DRAINAGE INFORMATION SHEET

PROJECT TITLE: VALLEJOS OFFICE BLDG. 2      ZONE ATLAS/DRNG. FILE #: H22/D64  
DRB #:      EPC #:      WORK ORDER #:  
LEGAL DESCRIPTION:  
CITY ADDRESS: 12306 MENAUL BLVD. NE 87112  
ENGINEERING FIRM: HALL ENGINEERING, INC.      CONTACT: RICHARD HALL  
ADDRESS: 6840 2ND ST., NW 87107      PHONE: 345-1064 FAX 344-5404  
OWNER: ANTHONY VALLEJOS      CONTACT:  
ADDRESS: 12306 MENAUL BLVD. NE      PHONE: 298-6363  
ARCHITECT: CHRIS LARSEN      CONTACT:  
ADDRESS: 202 CENTRAL AVE., SE      PHONE: 247-3705  
SURVEYOR: HALL ENGINEERING      CONTACT:  
ADDRESS:      PHONE:  
CONTRACTOR:      CONTACT:  
ADDRESS:      PHONE:

**RE: VALLEJOS OFFICE BLDG. #2 (H22/D64), 12306 MENUAL BLVD. NE.  
ENGINEER'S CERTIFICATION FOR CERTIFICATE OF OCCUPANCY.  
ENGINEER'S CERTIFICATION DATED APRIL 10, 1997.**

TIONS SHOWN HEREON ARE TO FINISH  
MINE APPROPRIATE SUBGRADES.

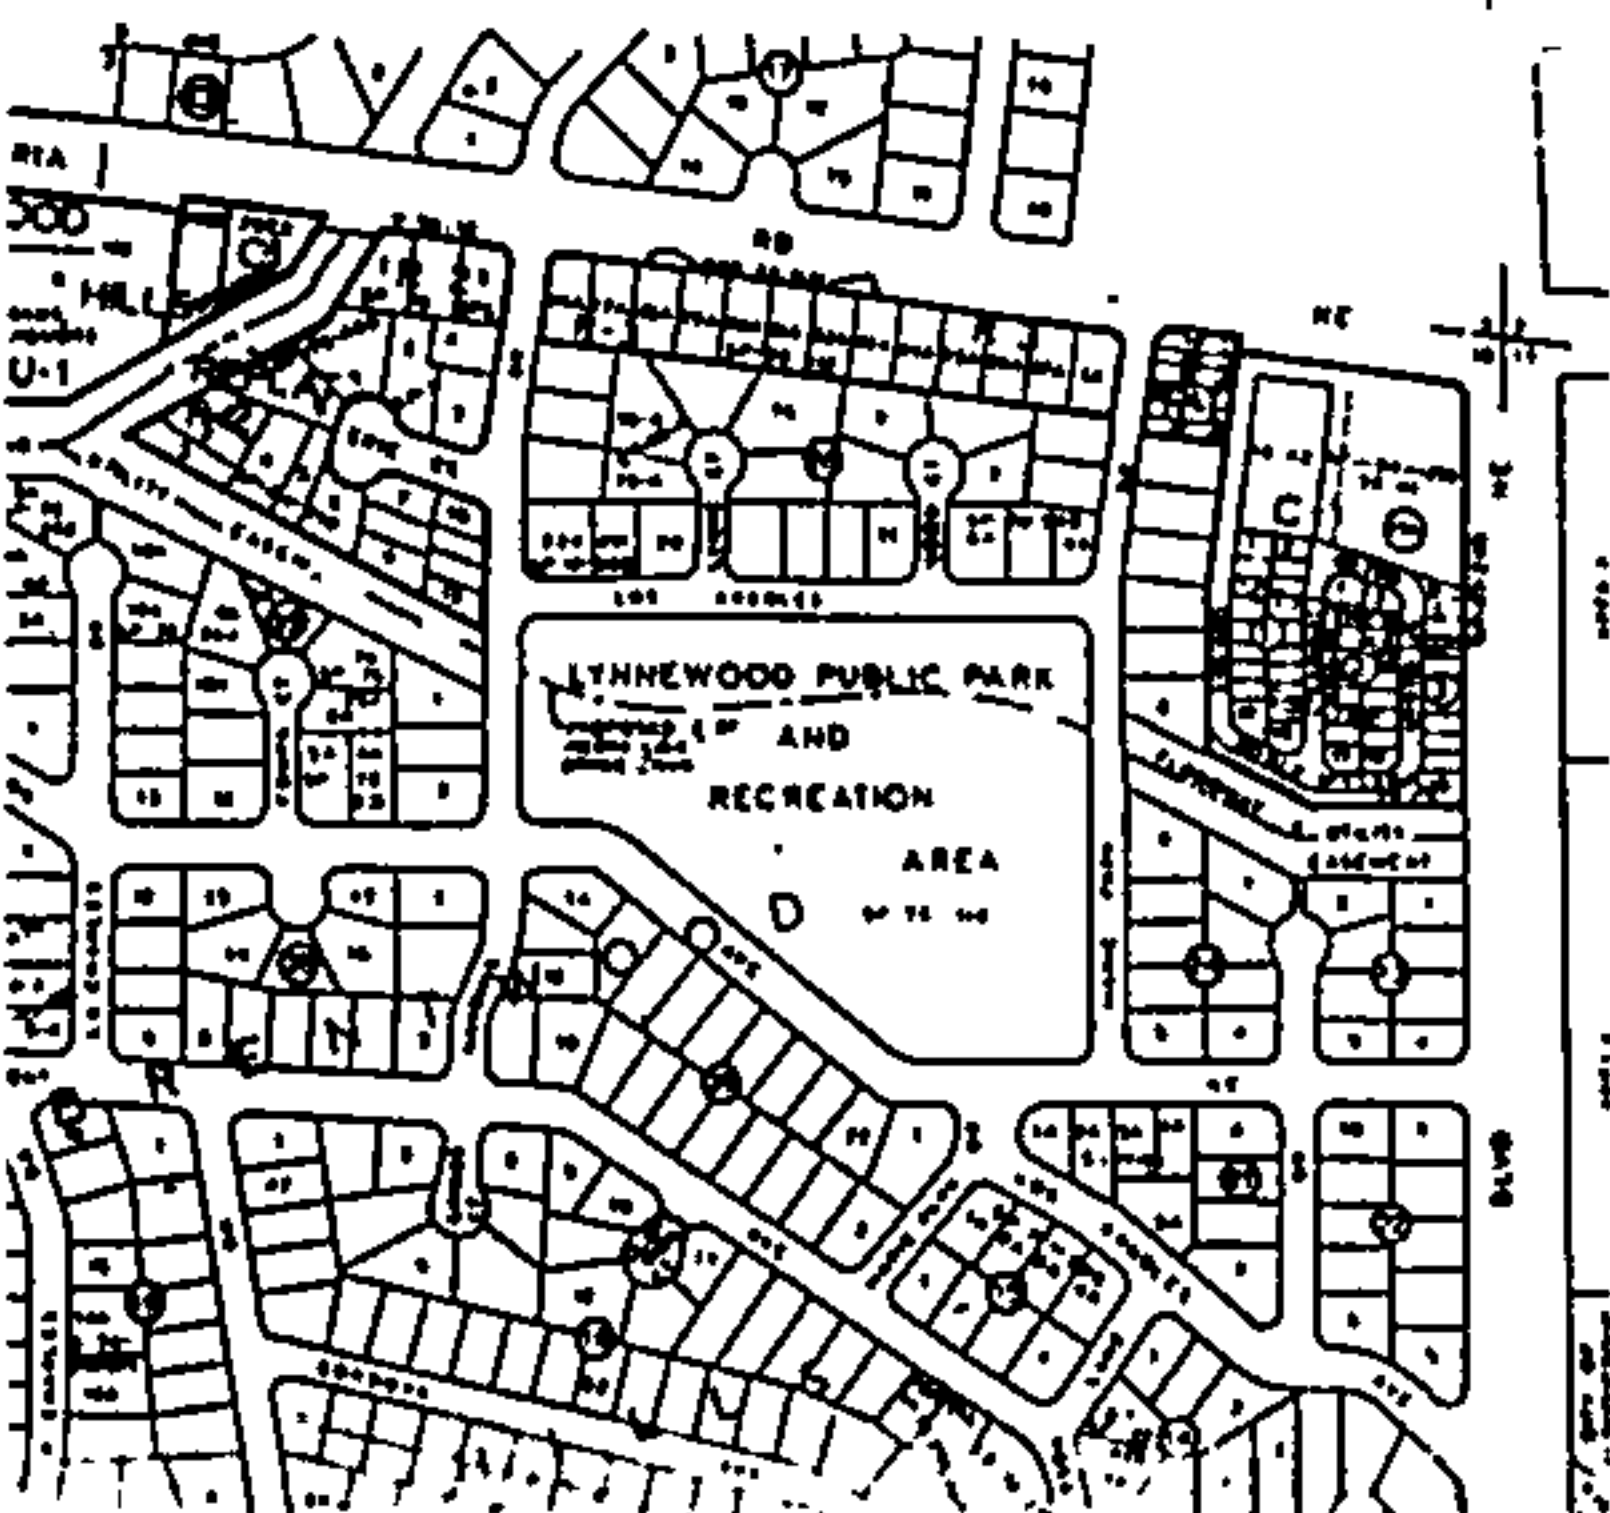
1. Is this site in a 100 year Flood Plain?
2. Provide hydrograph for detention pond per Figure A-3, DPM Section 22.2. (mark up attached). City Hydrology believes that required storage volume calculated is too low.
3. An S.O.19 is required for the sidewalk culvert. Add the Approval Block and Notice to Contractor to the Drainage Plan (form attached).
4. A Private Facility Drainage Covenant must be executed & filed for the Detention Pond (form attached).

We have complied with the items mentioned in your letter and have incorporated a second building with an extended parking area on the plan. There is to be no undeveloped area on the site, as amended.

1. This site is not in a 100-year flood zone but is contributory to one about 1/2 mile to the west near Juan Tabo Boulevard.
2. A hydrograph for detention has been calculated for the amended site and included on the plan sheet. The required storage volume was calculated to be 1220 ft<sup>3</sup>. 1237 ft<sup>3</sup> may be accommodated in the basin as designed.
3. S.O.19 signature block and notes to contractor have been added to the sheet.
4. Text has been amended where noted.
5. Private Facility Drainage Covenant form was forwarded to the Owner for his acknowledgement.
